# HISTORIC AND DESIGN REVIEW COMMISSION

July 19, 2023

**HDRC CASE NO:** 2023-227  
**ADDRESS:** 217 VANCE ST  
**LEGAL DESCRIPTION:** NCB 733 BLK 5 LOT 15, & E IRR 8 FT OF 14  
**ZONING:** R-6, H  
**CITY COUNCIL DIST.:** 1  
**DISTRICT:** Lavaca Historic District  
**APPLICANT:** Vicki Yuan  
**OWNER:** WALLACE ANNE REYNOLDS  
**TYPE OF WORK:** Demolition of a rear accessory structure and new construction of a 1-story rear accessory structure  
**APPLICATION RECEIVED:** June 05, 2023  
**60-DAY REVIEW:** August 4, 2023  
**CASE MANAGER:** Rachel Rettaliata

1. Demolish the existing 1-story rear carport structure.
2. Construct an approximately 864-square-foot, 1-story rear accessory structure.

BUILDING ELEVATIONS  
SCALE: 1/4" = 1'-0"

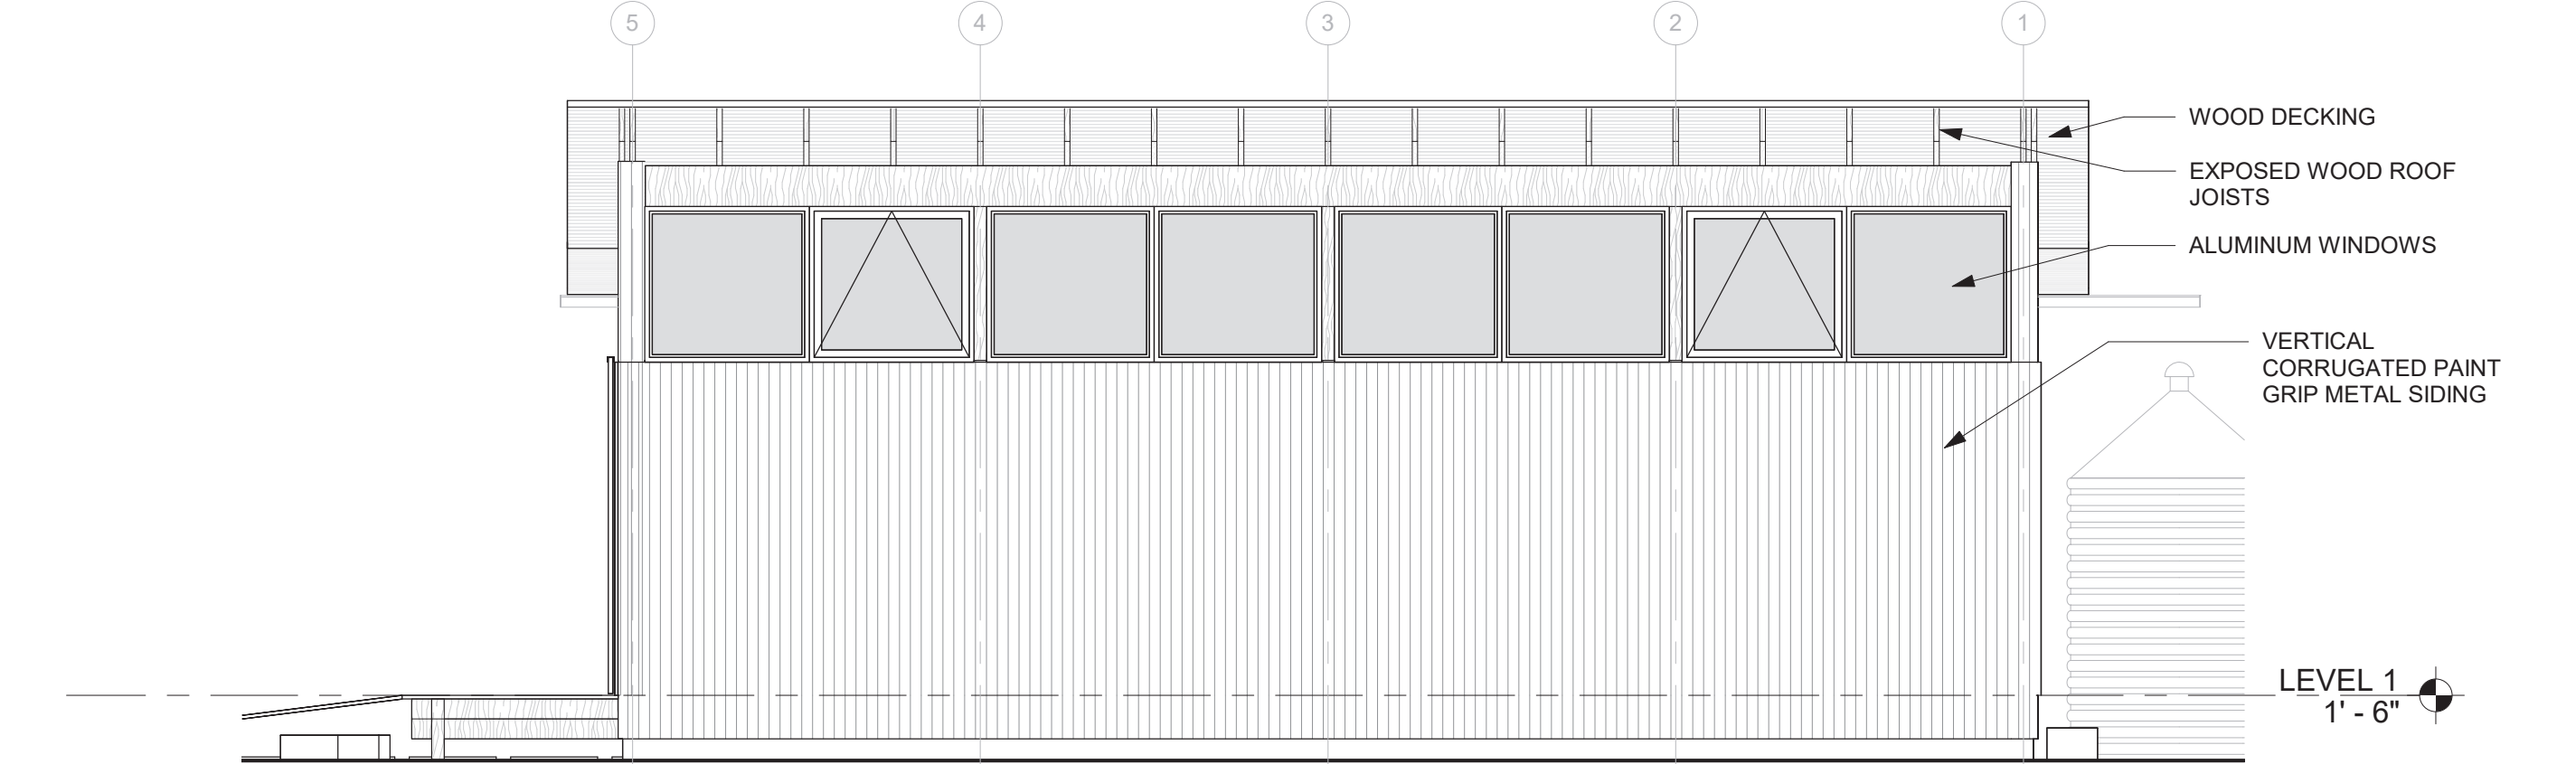
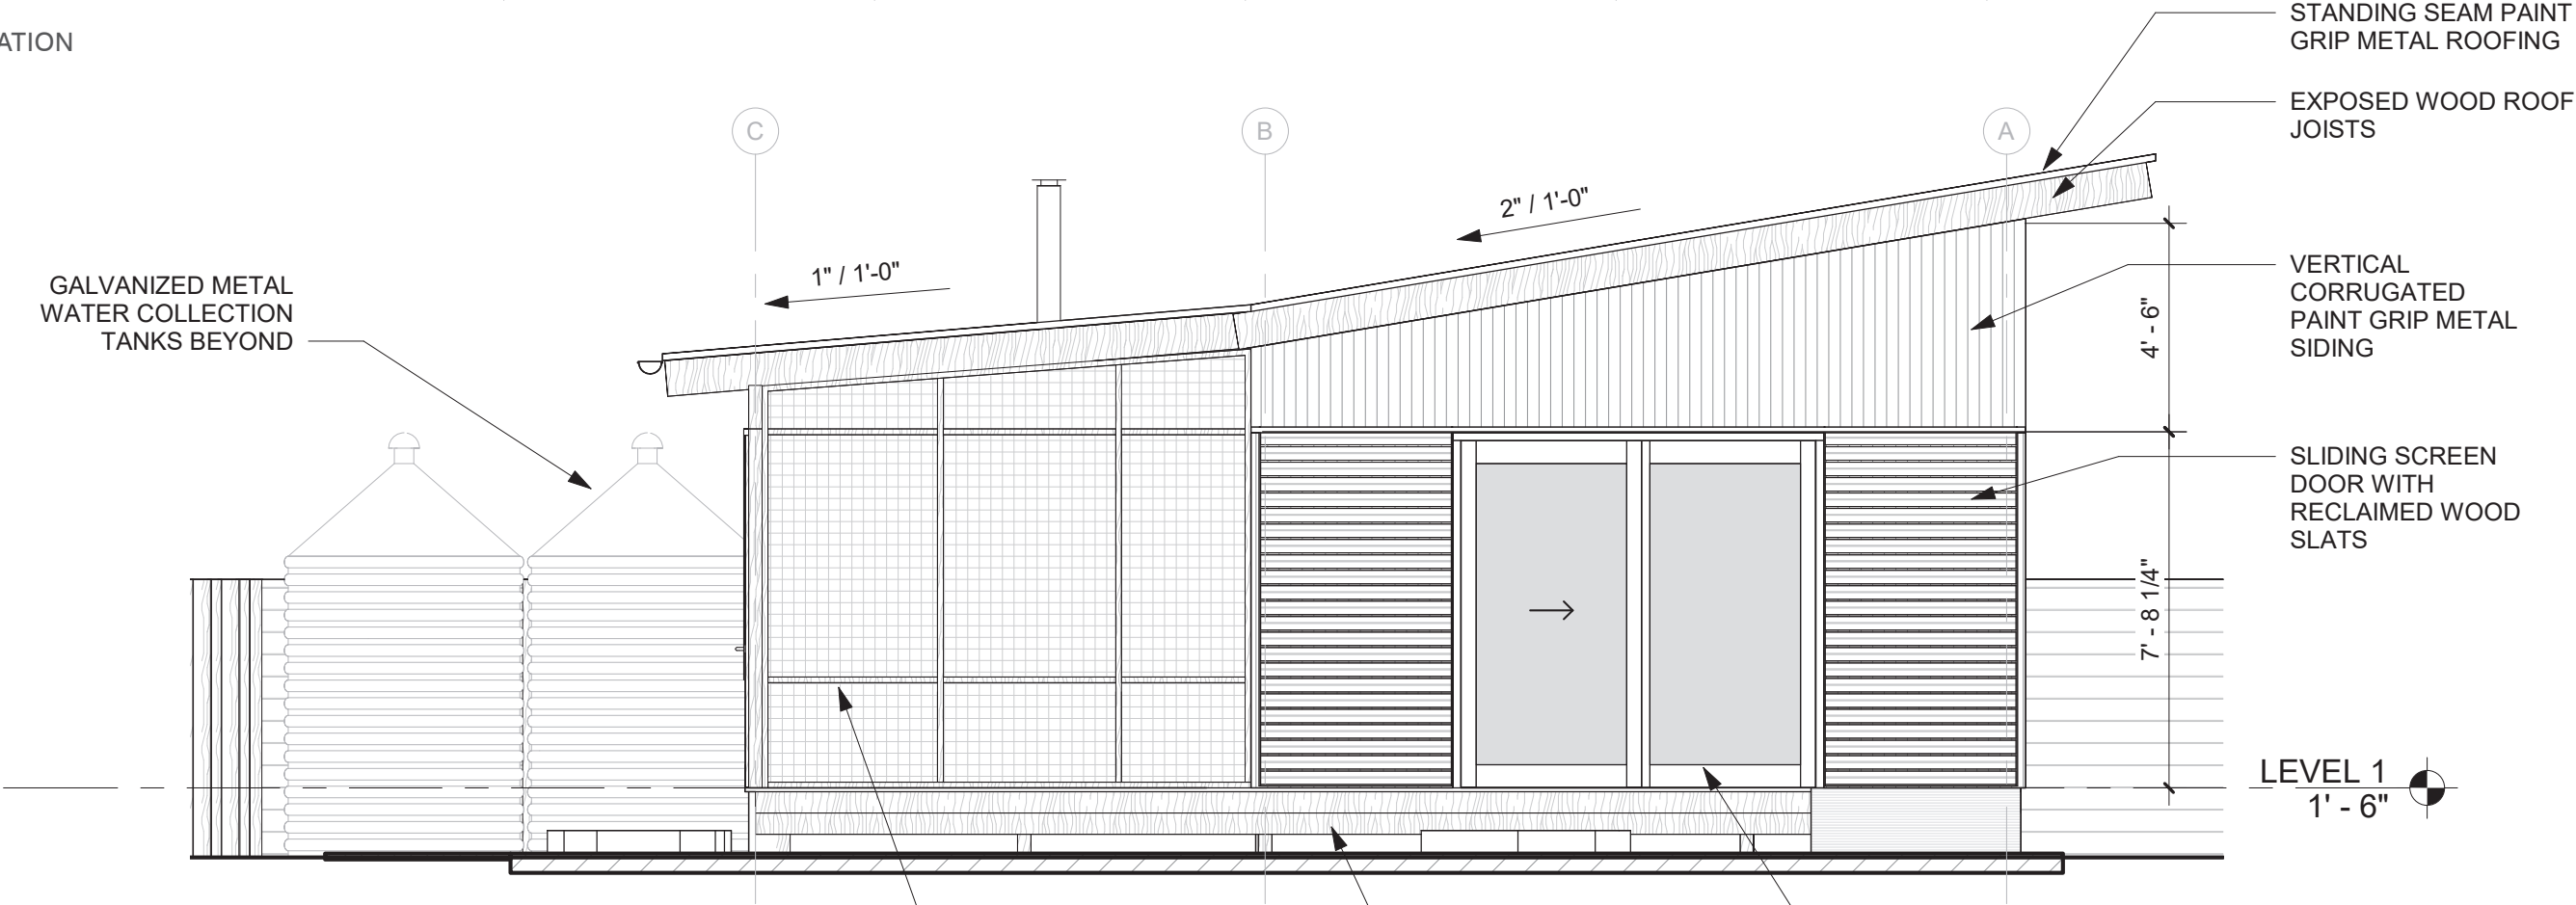
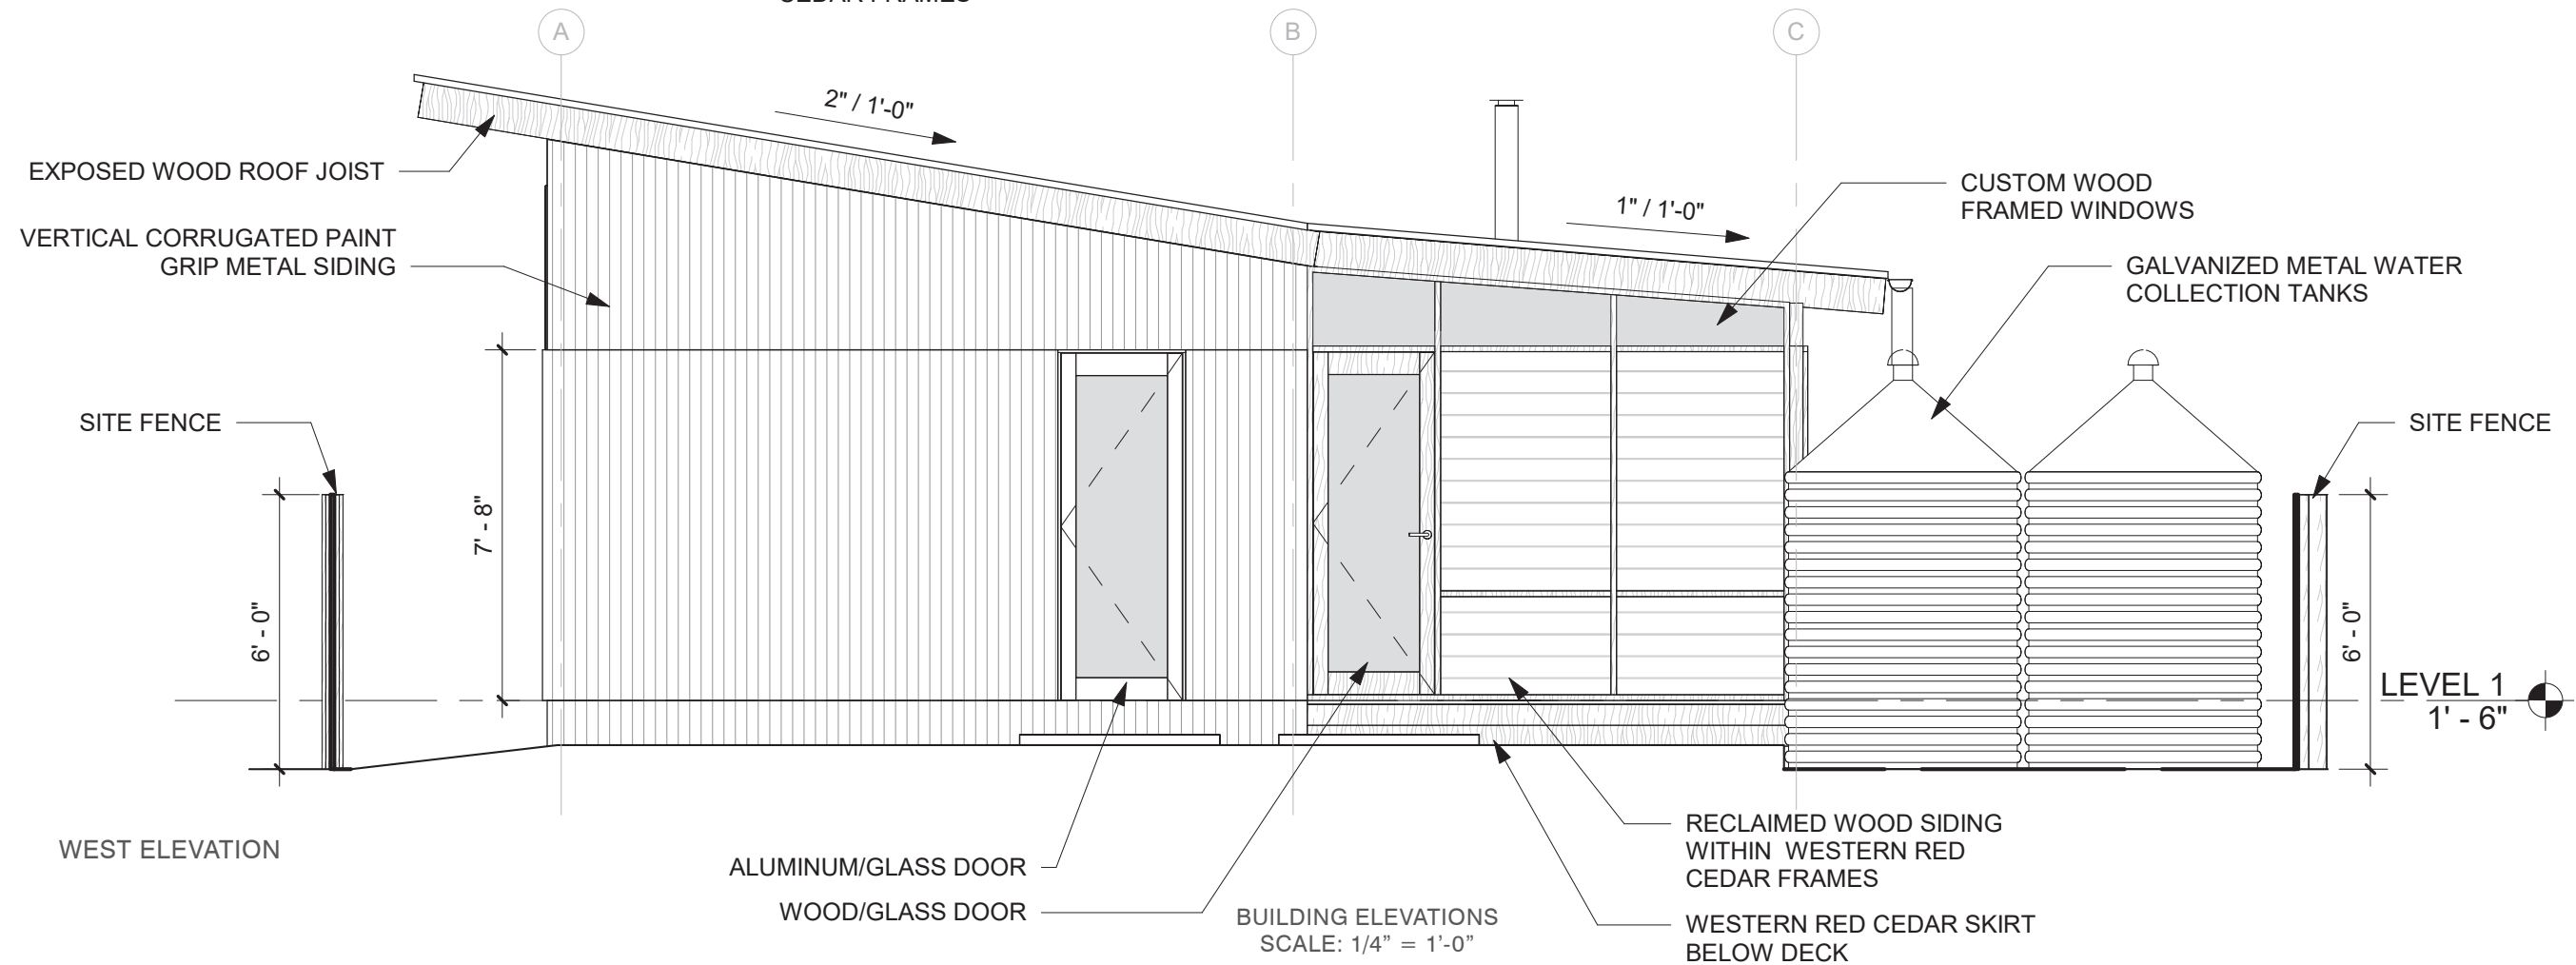
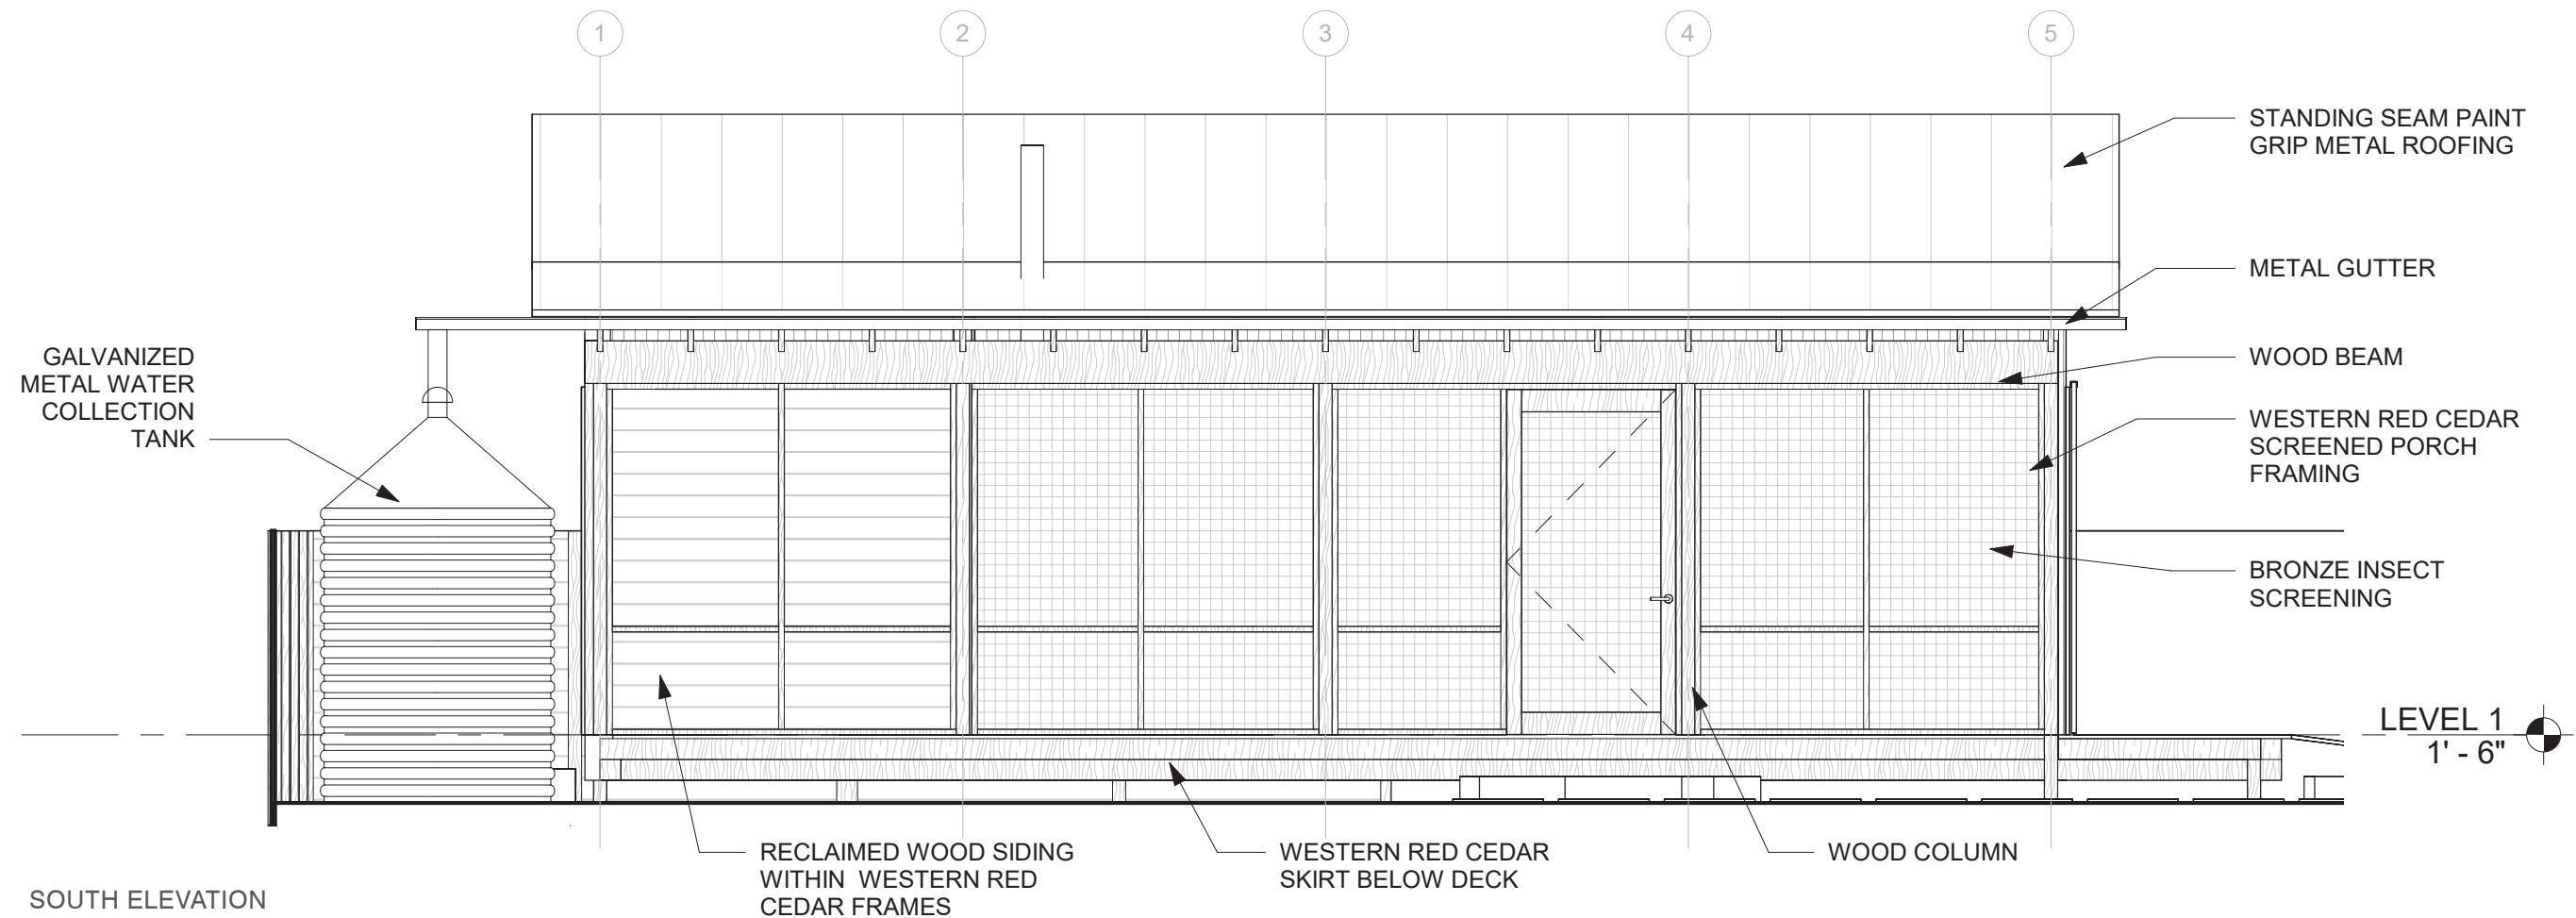
- 2b. SCALE & MASS – The applicant has proposed to construct a 1-story rear accessory structure. The applicant has not provided total height information at this time; however, the structure will feature a height of approximately 14 feet, not including the roof, at the highest point on the north elevation. The Historic Design Guidelines state that new construction should be consistent with the height and overall scale of nearby historic buildings and rear accessory structures. Staff finds that the applicant

- 2d. ROOF FORM – The applicant has proposed a shed roof form that is similar to a butterfly roof form with the highest point of the roof at the north elevation, sloping to the south side of the structure. Guideline 2.B.i for New Construction states that new construction should incorporate roof forms – pitch, overhangs, and orientation – that are consistent with those predominantly found on the block. The roof form on the existing rear accessory structure is a side gable roof form, the primary structure features a hip roof form, and the primary structure at 215 Vance features a front gable roof form. Primary and rear accessory structures on this block feature hip, front gable, and side gable roof forms. Staff finds that the applicant should submit a line-of-sight study showing that the rear accessory structure will not be visible from the public right-of-way.

- 2e. MATERIALS – The applicant has proposed a rear accessory structure that features a standing seam metal paint grip roof with wood decking at the roof eaves and exposed wood roof joists, corrugated metal paint grip siding, reclaimed wood accents, western red cedar screened porch framing, and bronze insect screening. Guideline 3.A.i for New Construction states that new construction should feature materials that complement the type, color, and texture of materials traditionally found in the district. Materials should not be so dissimilar as to distract from the historic interpretation of the district. For example, corrugated metal siding would not be appropriate for a new structure in a district comprised of homes with wood siding. Guideline 3.A.v for New Construction states that vinyl siding, plastic, or corrugated metal sheeting should not be used. Contemporary materials not traditionally used in the district, such as brick or simulated stone veneer and Hardie Board or other fiberboard siding, may be appropriate for new construction in some locations as long as new materials are visually similar to the traditional material in dimension, finish, and texture. Staff finds the use of corrugated metal siding to be inconsistent with the Guidelines and finds that the applicant should propose an alternate cladding material that complements the type, color, and texture of materials traditionally found in the district or should limit the use of corrugated metal as an accent or secondary material.

- 2f. MATERIALS: DOORS AND WINDOWS – The applicant has proposed to install aluminum windows on the north elevation, an aluminum sliding entry door on the east elevation, a full lite aluminum door on the west elevation, a full lite wood door on the screened porch of the west elevation, a screen door on the south elevation, and a sliding door on the interior of the screened porch on the south elevation. Wood or aluminum-clad wood windows are most appropriate; however, an alternative window material may be proposed, provided that the windows feature an inset of two (2) inches within facades and should feature profiles that are found historically within the immediate vicinity. White manufacturer's color is not allowed, and color selection must be presented to staff. There should be a minimum of two inches in depth between the front face of the window trim and the front face of the top window sash. This must be accomplished by recessing the window sufficiently within the opening or with the installation of additional window trim to add thickness. Window trim must feature traditional dimensions and an architecturally appropriate sill detail. Window track components must be painted to match the window trim or be concealed by a wood window screen set within the opening. Staff finds that the applicant should submit product specifications for the proposed windows and doors to staff for review.

- 2g. RELATIONSHIP OF SOLIDS TO VOIDS – Guideline 2.C.i for New Construction stipulates that new construction should incorporate window and door openings with a similar proportion of wall to window space as typical with nearby historic facades. Windows, doors, porches, entryways, dormers, bays, and pediments shall be considered similar if they are no larger than 25% in size and vary no more than 10% in height to width ratio from adjacent historic facades. Guideline 5.A.iv for New Construction states that window and door openings should be designed to be similar to those found on historic garages or outbuildings in the district or on the principle historic structure in terms of their spacing and proportions. The applicant has proposed to install square fixed and operable windows as a row of clerestory windows on the north elevation. Staff finds that the proposed windows are consistent with the architectural design

- ii. That the applicant submits documentation showing the proposed height and scale in relation to the adjacent primary structures and neighboring rear accessory structures to staff for review and approval prior to the issuance of a Certificate of Appropriateness based on finding 2b.

- iii. That the applicant submits a line-of-sight study showing that the rear accessory structure will not be visible from the public right-of-way to staff for review and approval prior to the issuance of a Certificate of Appropriateness based on finding 2d.

- iv. That the applicant proposes an alternate cladding material that complements the type, color, and texture of materials traditionally found in the district or limits the use of corrugated metal as an accent or secondary material based on finding 2e and submits updated elevation drawings and material specifications to staff for review and approval prior to the issuance of a Certificate of Appropriateness.

- v. That the applicant submits window and door product specifications to staff for review and approval prior to the issuance of a Certificate of Appropriateness based on finding 2f. Wood windows or aluminum-clad windows are most appropriate; however, an alternative window material may be proposed, provided that the window features an inset of two (2) inches within facades and should feature profiles that are found historically within the immediate vicinity. White manufacturer's color is not allowed, and color selection must be presented to staff. There should be a minimum of two inches in depth between the front face of the window trim and the front face of the top window sash. This must be accomplished by recessing the window sufficiently within the opening or with the installation of additional window trim to add thickness. Window trim must feature traditional dimensions and architecturally appropriate sill detail. Window track components must be painted to match the window trim or concealed by a wood window screen set within the opening.
